April 28, 2014
Via e-mail & 1st Class Mail

RE: FEMA Flood Map Revisions
Bay Side V-Zones
Borough of Mantoloking, Ocean County

Hatch Mott MacDonald (HMM) is submitting this letter on behalf of the Borough of Mantoloking in response to FEMA's letter dated March 28, 2014, in which FEMA invited comments on the Preliminary FIRM and FIS report. Our comments include: follow-up of previously submitted comments regarding probability and wind direction and wave height analysis (addressed in FEMA's February 24, 2014 letter); responses to requests for additional information contained in FEMA's February 24, 2014 letter; elevation information obtained by a Professional Land Surveyor along the bayside transects and recommendations on using this supplemental information to delineate more accurate flood zones; and additional concerns prepared following a detailed review of the Preliminary FIRM and FIS.

Preliminary FIRM Review
Borough of Mantoloking
Map No. 34029C0216G

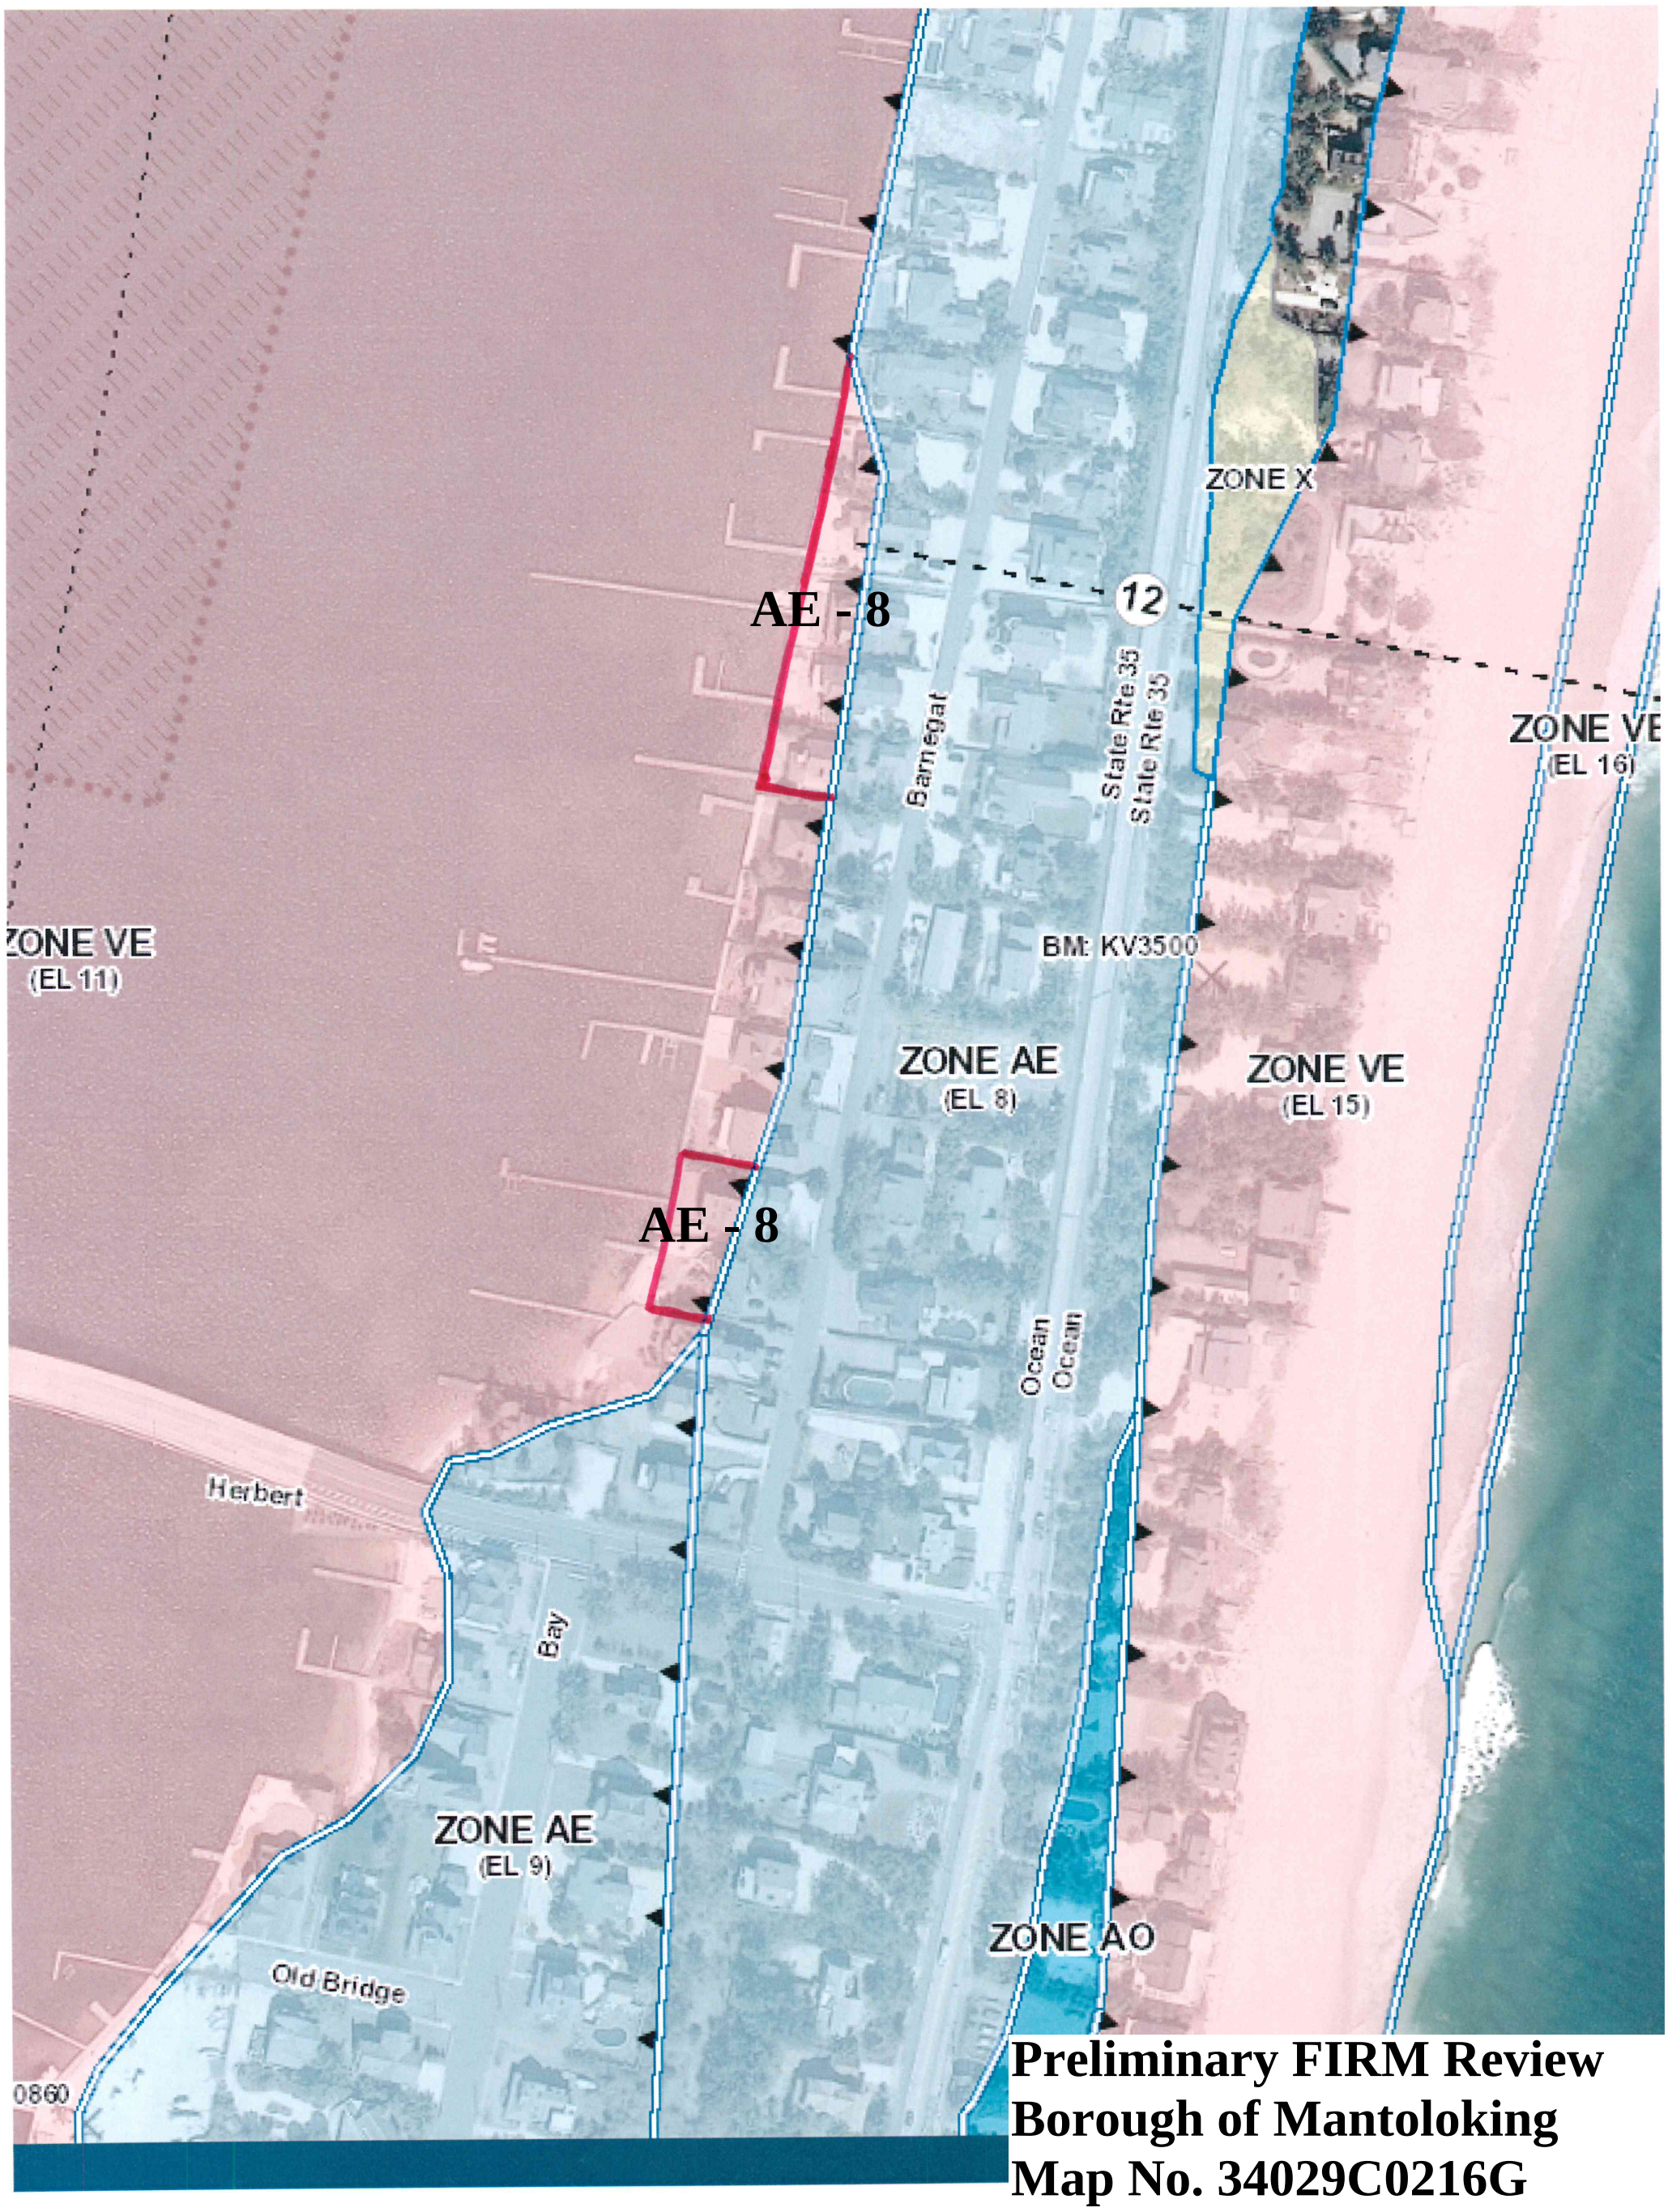
- As indicated in the FIS and mentioned in Section 3.0 of this report, transect elevation data is used to determine the expected height of the wave crests and run-up utilized by WHAFIS modeling to determine the FIRM's flood boundary limits. As these transects are quiet a distance apart, it is mentioned that elevations were interpolated using topographic maps, land-use and land-cover data and engineering judgment to determine the extent of the flood zones. HMM has reviewed these determinations of the proposed zones and offers at least three (3) distinct proposed revisions per the attached Plates (1-3), where significant grade changes exist which were not captured in the flood mapping. Please note that the suggested revisions shown on Plates 1-3 are meant to serve as examples of how the flood zones may be redrawn based on the additional provided survey information along the transects as well as on the high-accuracy topographic mapping, which we have attached for your use and

consideration. They are not meant to represent a precise delineation of those zones, but an outcome that we would expect as a result of more detailed analysis to be performed by FEMA, utilizing underlying data in your possession. We can also provide the detailed topographic data in a CAD file, in NAD83 and NAVD88 datums, for your use.
